# Evidence Book 14

## Township of Guelph/Eramosa Blasting Impact Review Document Book

# Township of Guelph/Eramosa

**Re: Peer Review, Acoustical Study  
Hidden Quarry  
Novus Project No. 12-0258**

**Figure 3.**

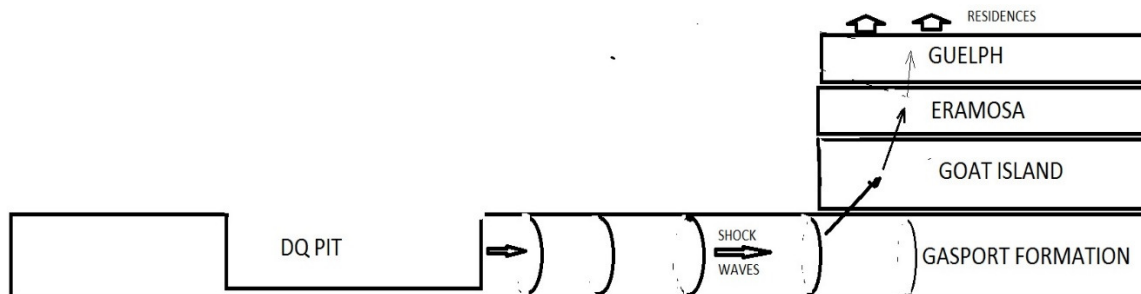
- Mr. Hill has the geological strata in which the Dolime Quarry is operating incorrectly represented. The Dolime quarry generally operates in the Guelph Formation and the Eramosa member. Hill July 22 Memo Figure 3.
